## REPORT TO PLANNING COMMISSION City of Sacramento

**Subject: Duckhorn Office Complex Phases 1B & 2.** A request to identify the intensity and types of uses in the EC-40-PUD zone and to develop a 14,283± square foot office/medical office building on 1.09± acres (Phase 1B) and a 60,000± square foot office/medical office building on 2.48± acres (Phase 2) in the Employment Center 40 (EC-40-PUD) zone in the Gateway West/Cambay West PUD. **(P06-216)**

Subject: Duckhorn Office Complex Phases 1B & 2 (P06-216)

Exhibit 1H: Phase 2 Site Plan

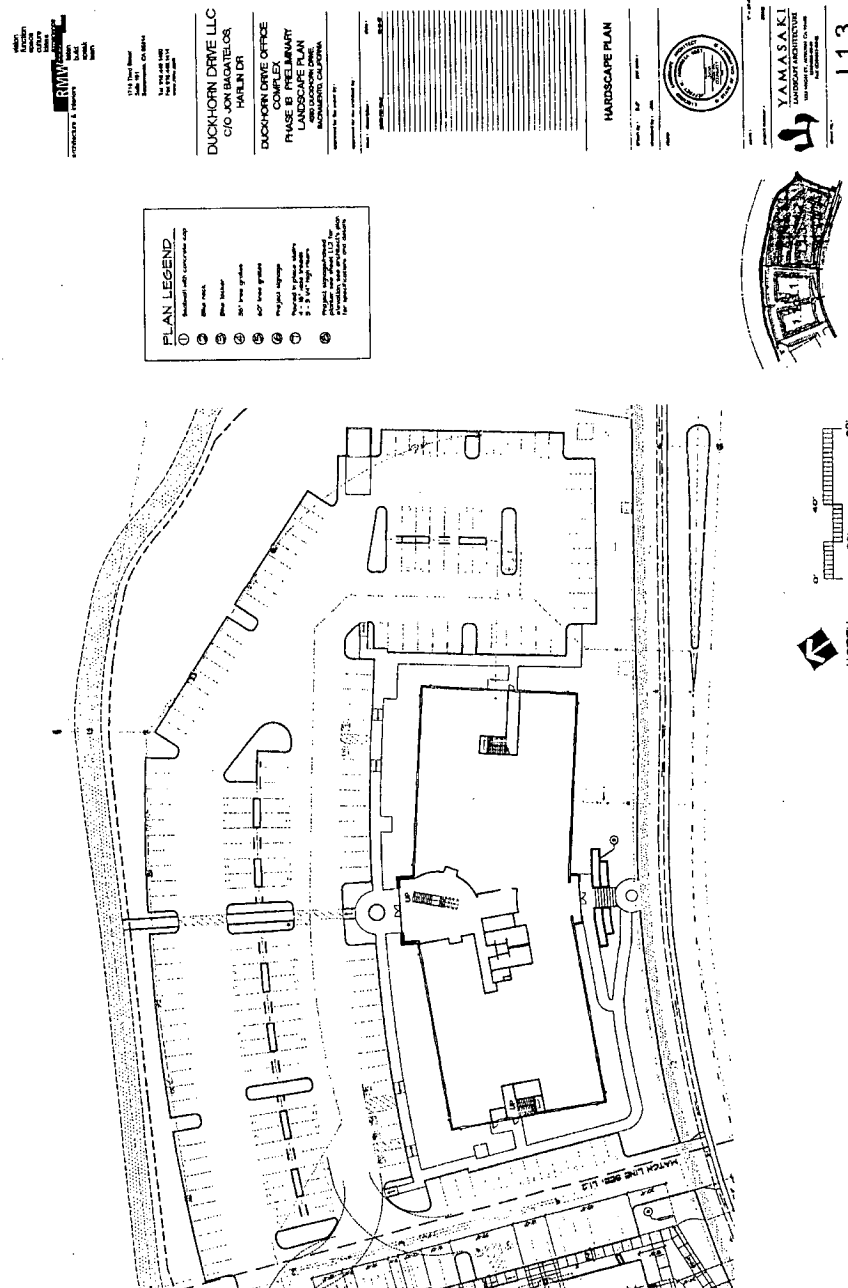
1. The bicycle lockers on parcel 2 should have at least 5' unobstructed hardscape at each end. *Added as an Advisory Note.*
2. Specify the bicycle racks as "one class II bicycle rack or one inverted 'U', 'A', or post-and-loop rack per bicycle parking space." *Added as an Advisory Note.*

7. Add a pedestrian walkway from the bicycle lockers on parcel 5 to the front entrance and the public sidewalk. *A pedestrian walkway has been shown to connect the side entry on the south side of the building to the sidewalk to allow access to the building.*

Exhibit 11: Phase 2 Landscape Plan

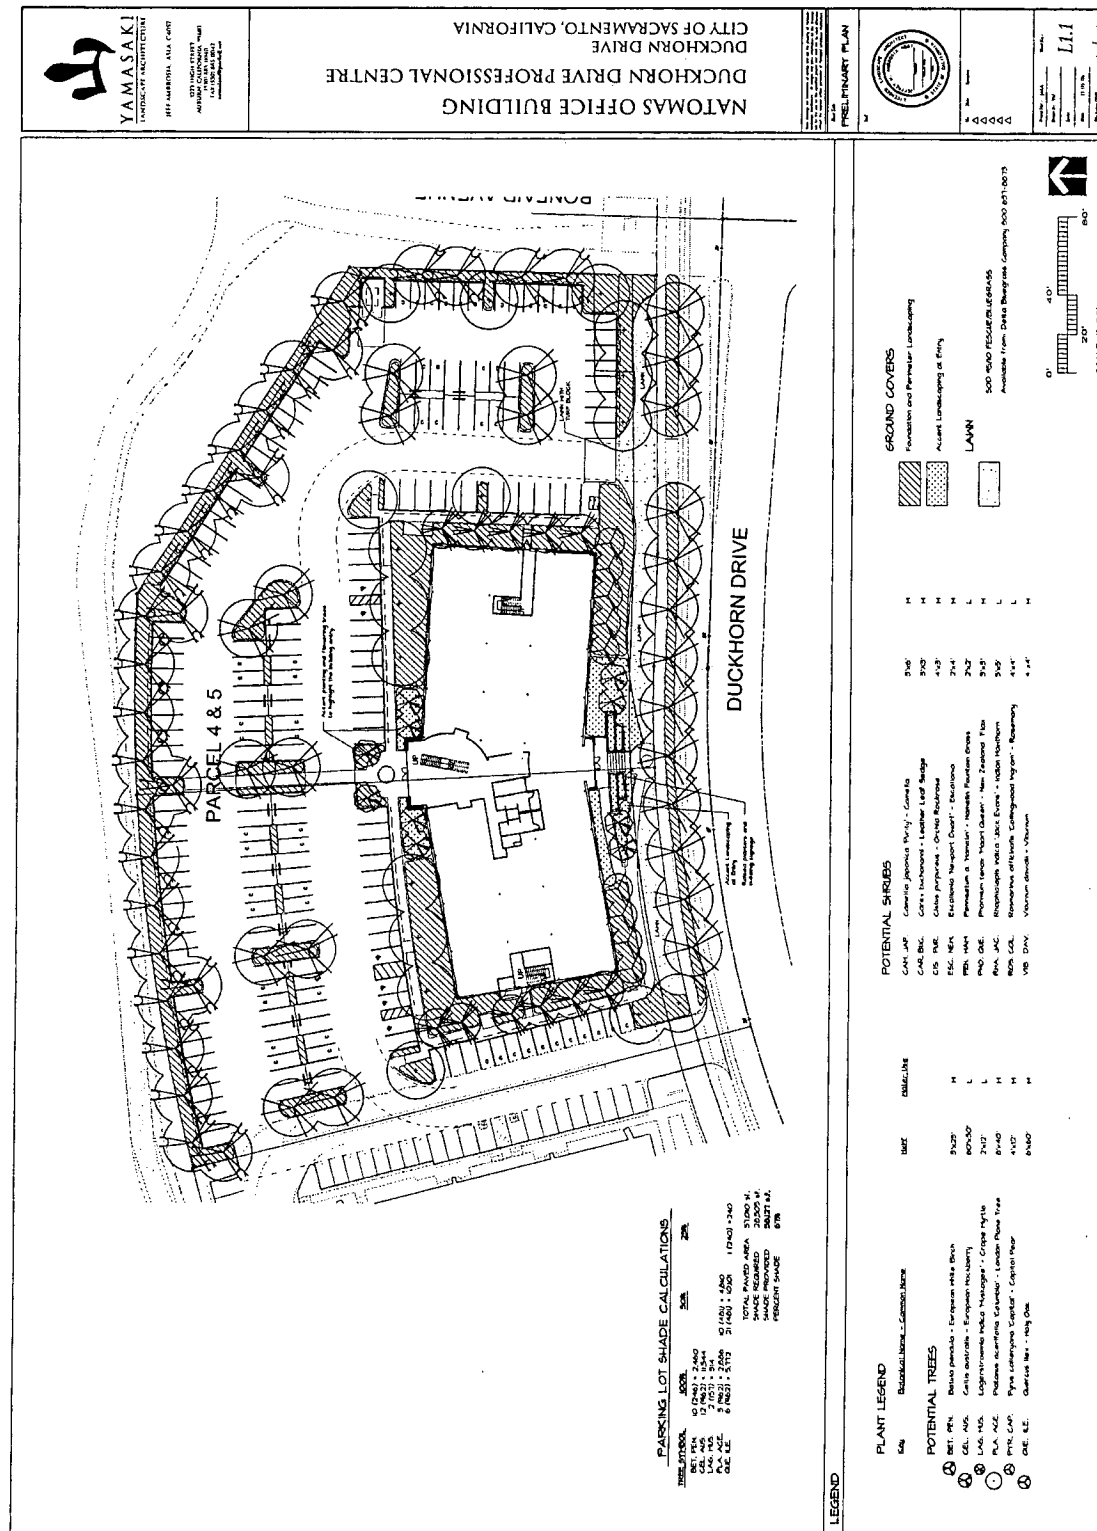
- D47. A minimum planter width of 7' will be required to provide adequate root space for medium/large and large canopy trees, (see species selection). Three of the planter widths shown in the east half of the parking lot less than 7' wide (net) will likely lead to tree root displacement of curb, sidewalk and asphalt well before trees are mature.

- D48. A revised landscape plan shall be submitted to show a minimum park strip planter width of 7' along Duckhorn.
- D49. *Platanus acerfolia* is an over planted species in Sacramento and shall be used sparingly.

The landscape plans appear to have insufficient parking lot shading. By inspection, approximately one-third of the parking area for parcels 2 and 3 is shaded. The discrepancy between the 58% shading figure stated on the landscape drawing and 33% may be due to the size of the tree symbols being too small. As an example, the symbol for *Quercus ilex* is about 3-½ standard parking spaces wide or 28'. The area of each symbol on the drawing would appear to be about 25% greater if the symbols were the correct size (35'), but the calculated shaded area would decrease because the percentage assigned to many of the overlapping trees may decrease from 50% to 25%. The shade percentage for parcels 4 and 5 also appears to be less than required for the same reasons stated above.
